TWIN CHIMNEYS

VILLAGE F

PLAT THREE

STORM & SANITARY SEWER MEASUREMENTS

4
13

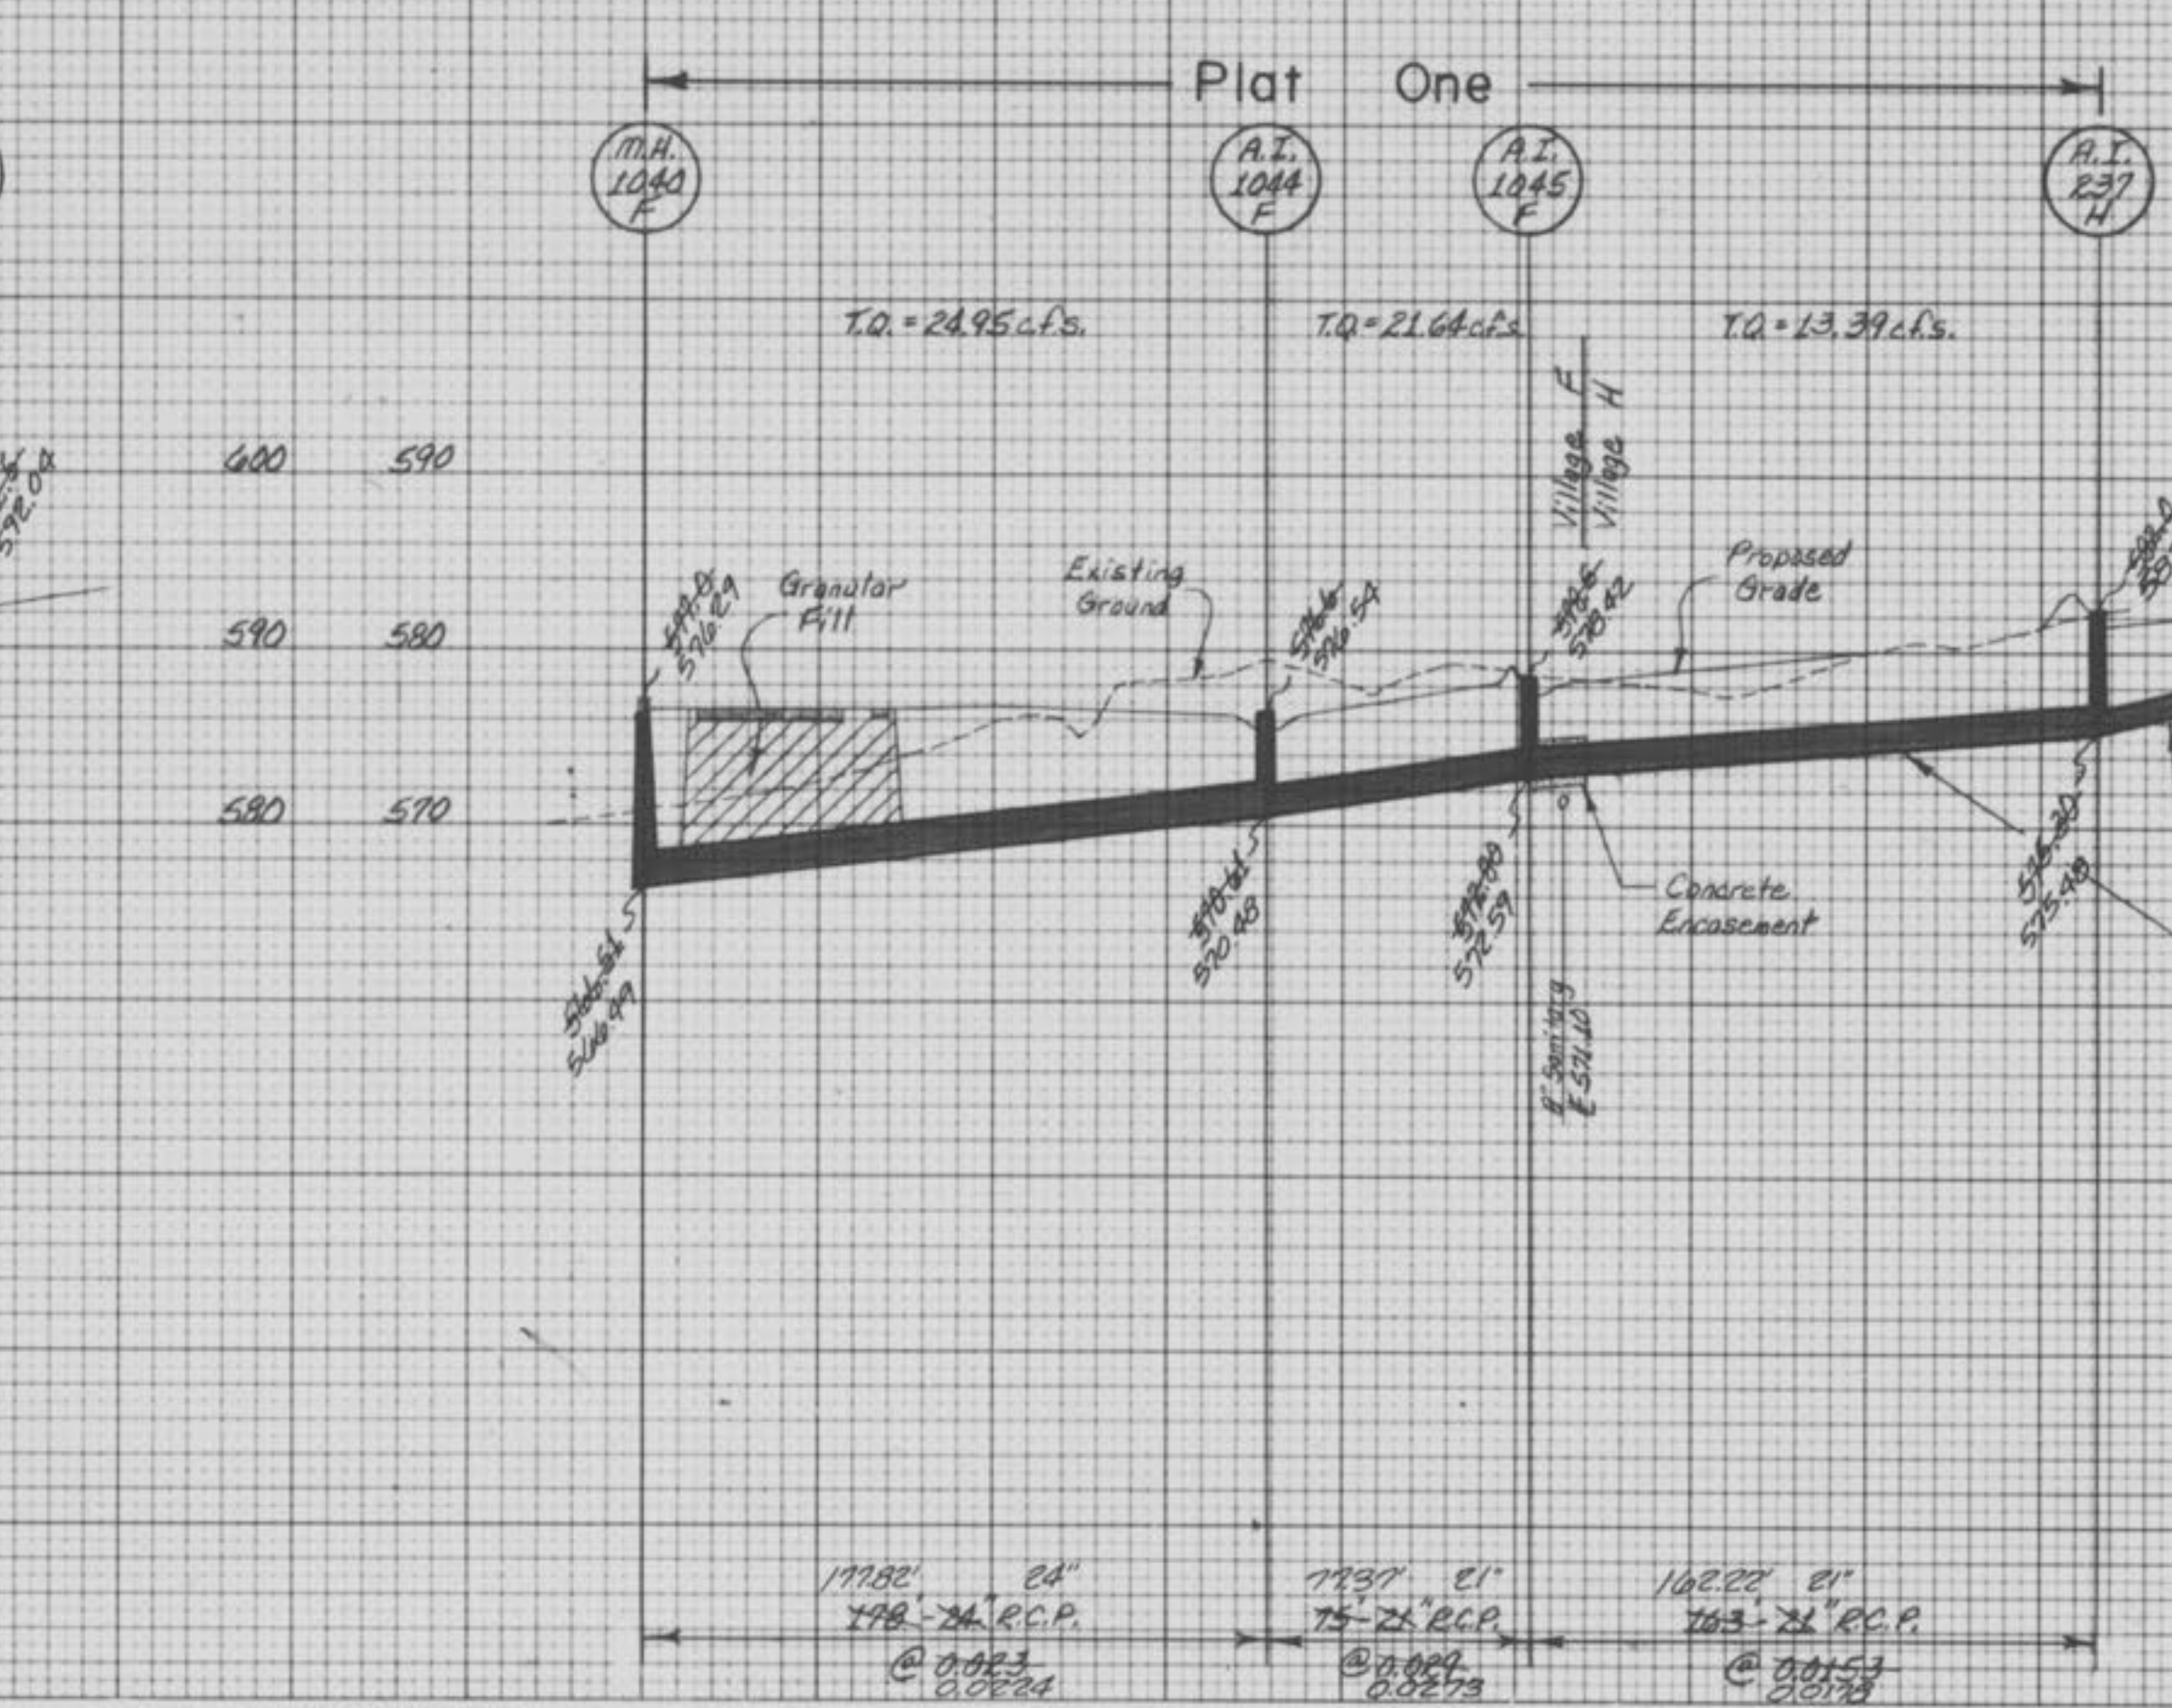
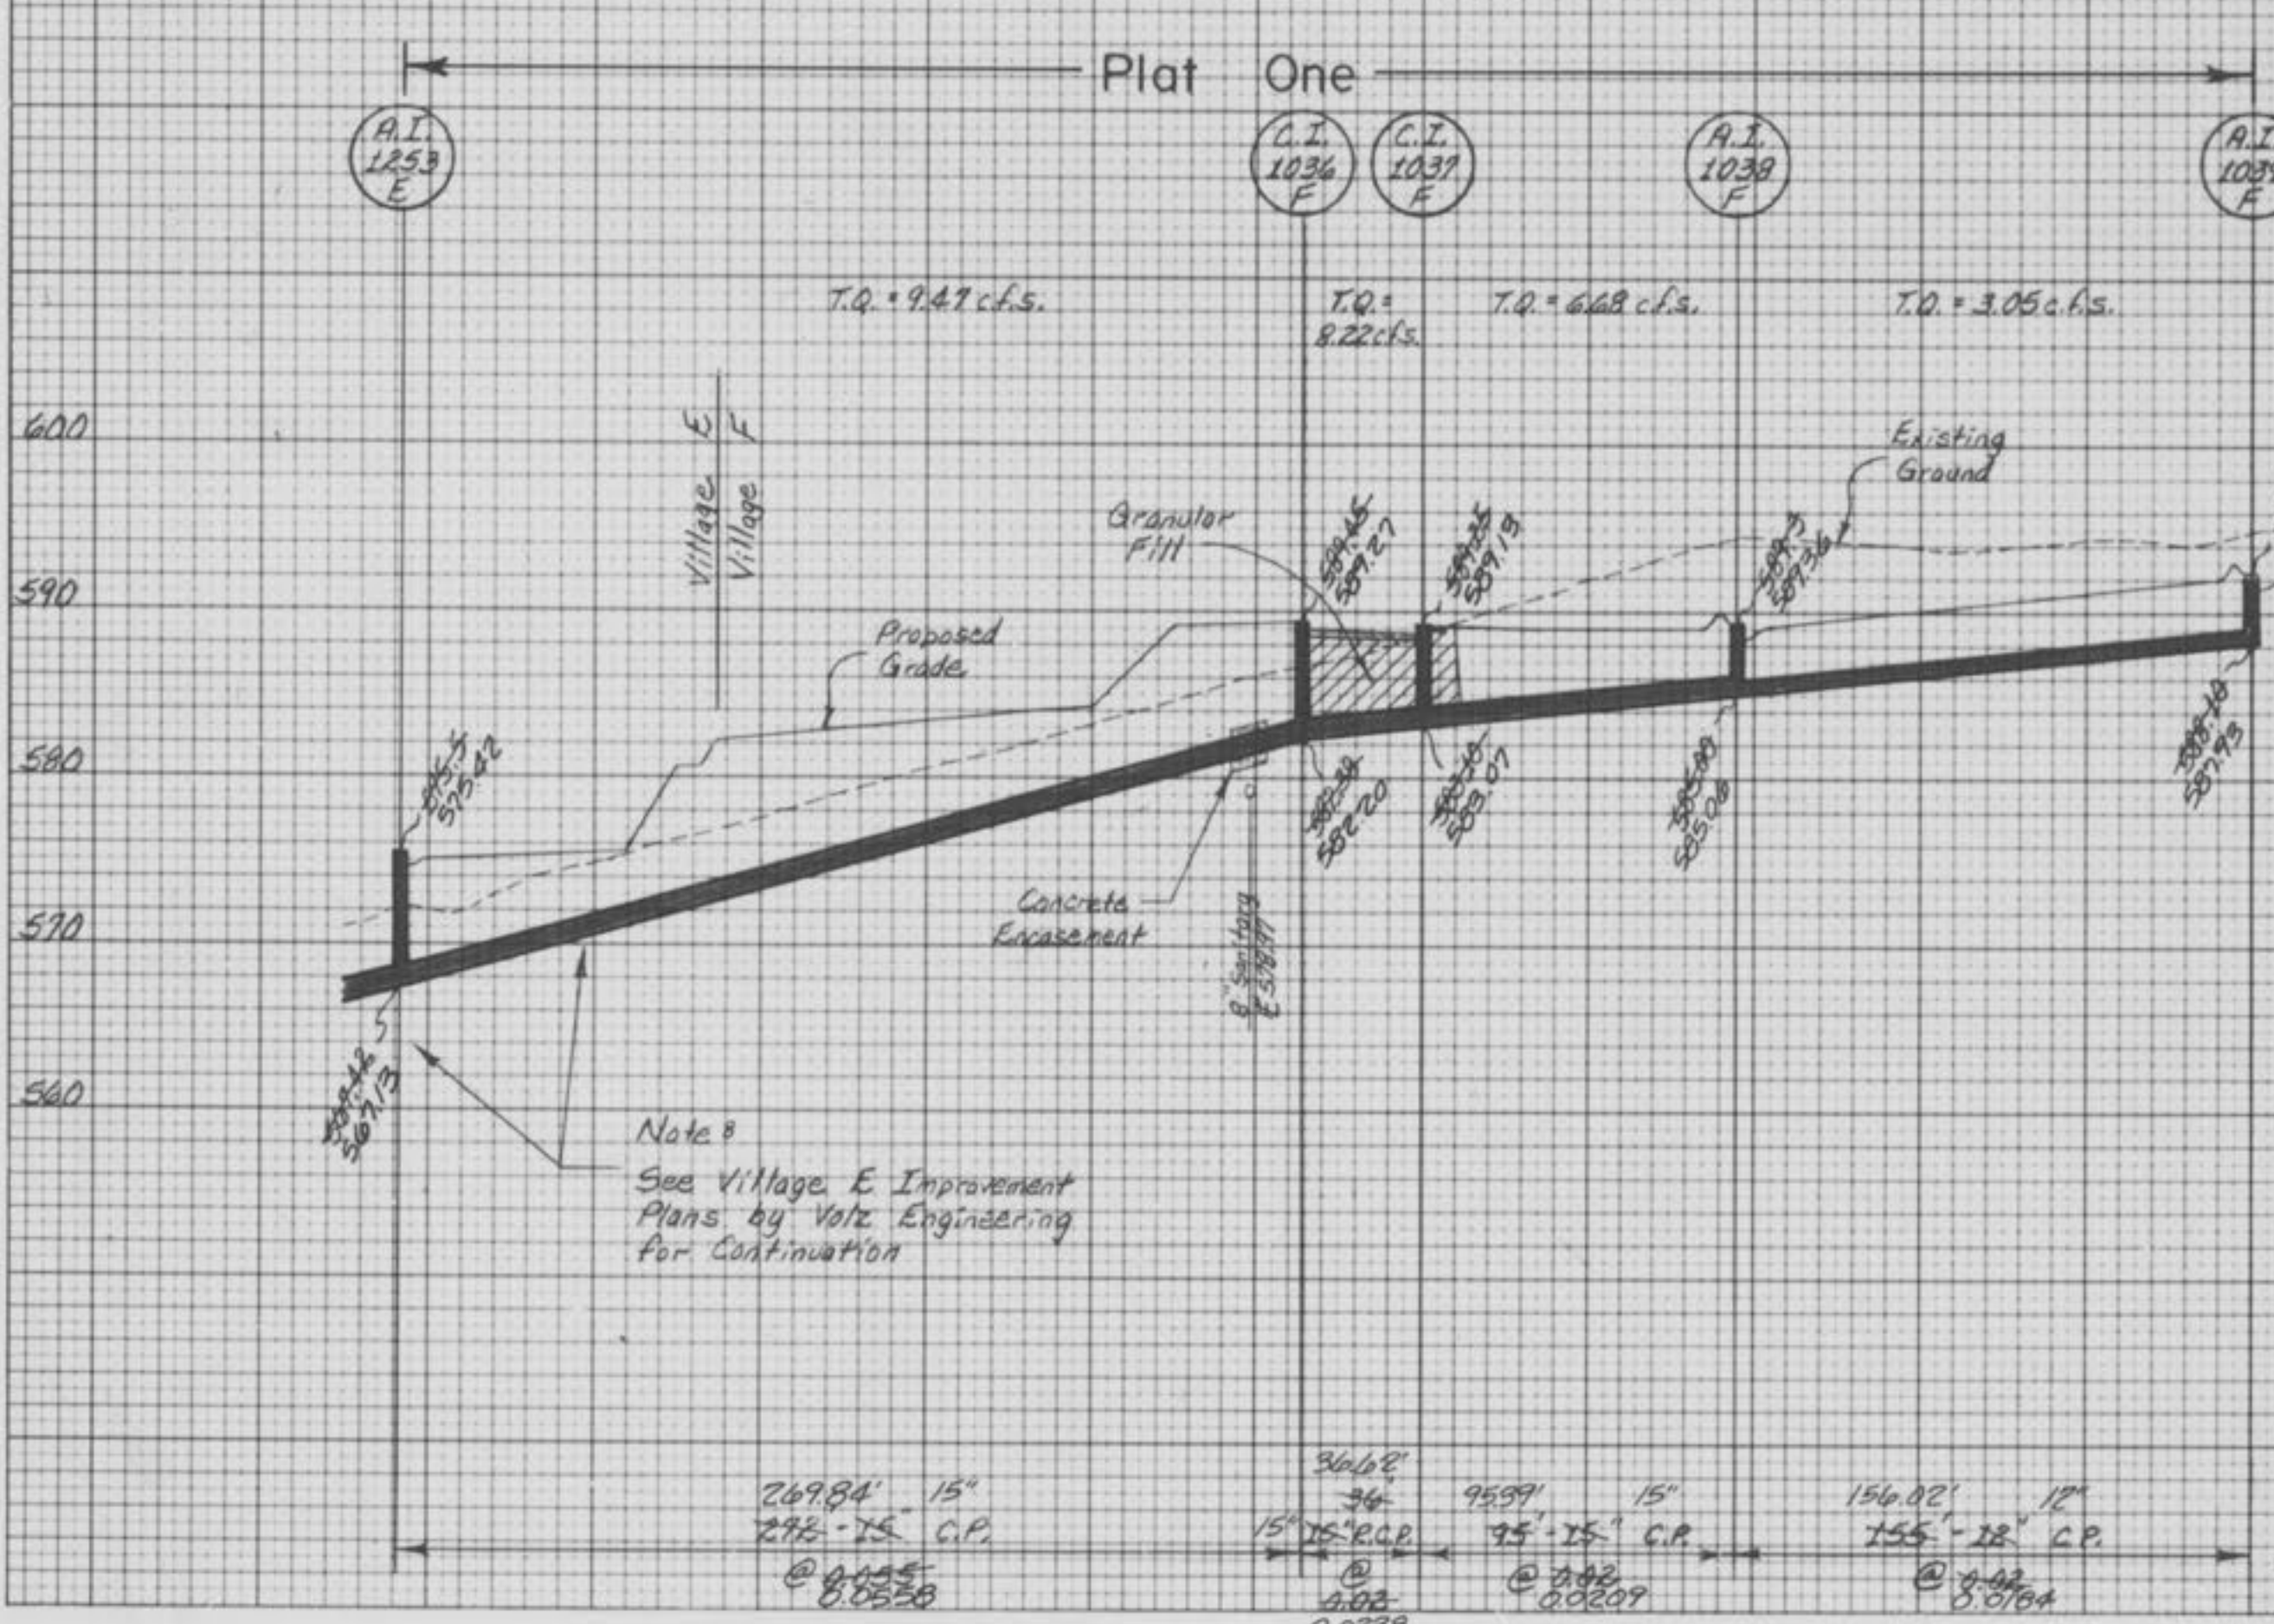
We have measured the existing sewer lengths, sizes, flowlines, depths of structures and the results of these measurements are shown on this plan by lining out the planned number and indicating the measured number adjacent to the planned number. All other numbers have not been measured or verified.
